Quad Cities Nuclear Power Station, Units 1 and 2
Facility Operating License Nos. DPR-29 and DPR-30
NRC Docket Nos. 50-254 and 50-265

Subject: Response to Request for Additional Information Concerning Risk Informed Inservice Inspection Program Alternative to the ASME Boiler and Pressure Vessel Code Section XI Requirements for Class 1 and 2 Piping Welds

ATTACHMENT

Figure RAI 9-A Comparison of Inspection Effectiveness Factors for EPRI RI-ISI Exams at QC Units 1 and 2

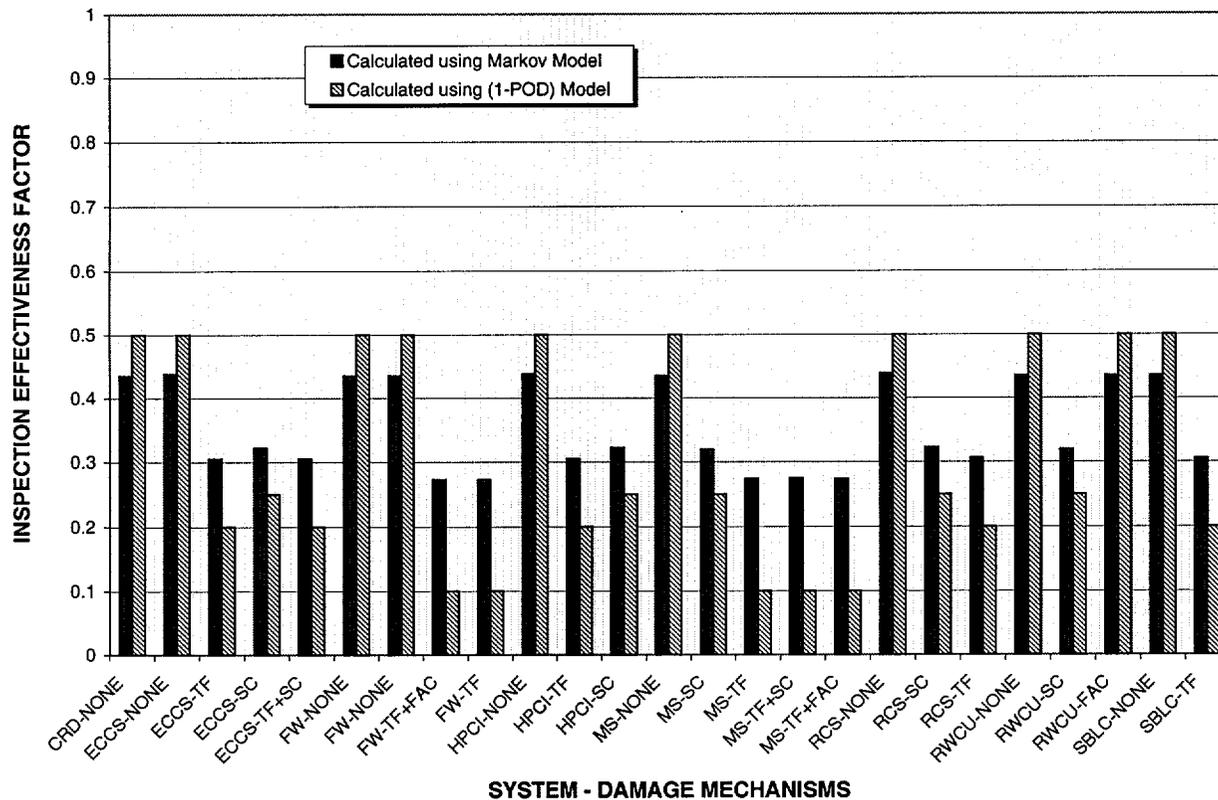
It is our understanding that you are calculating an inspection effectiveness factor (IEF) for use in equation 3-9 of EPRI TR-112657. Please provide a table identifying the probability of detection, the time to detect a leak, and the resulting IEF for all the IEFs used in the submittal.

A tabulation of all the unique inspection effectiveness factors for all pipe segments evaluated within the scope of the RI-ISI evaluation for QC Units 1 and 2 is presented in Table RAI 9-A. For comparison purposes, the corresponding POD values that were used were presented along with their complements that provide the alternative method of computing the inspection effectiveness factor. A plot that compares the two approaches to computing the inspection effectiveness factors is provided in Figure RAI 9-A for the RI-ISI exams.

As seen in these exhibits, there is fairly good agreement between these alternative approaches to estimating the inspection effectiveness factors. When the POD values are around 0.50, the Markov model predicts a somewhat higher level of inspection effectiveness, as reflected in somewhat lower inspection effectiveness factors. For higher POD values, the Markov model predicts a somewhat lower level of inspection effectiveness, as reflected in somewhat higher inspection effectiveness factors. Details documenting the inputs to computing these factors are discussed in response to question 8 above.
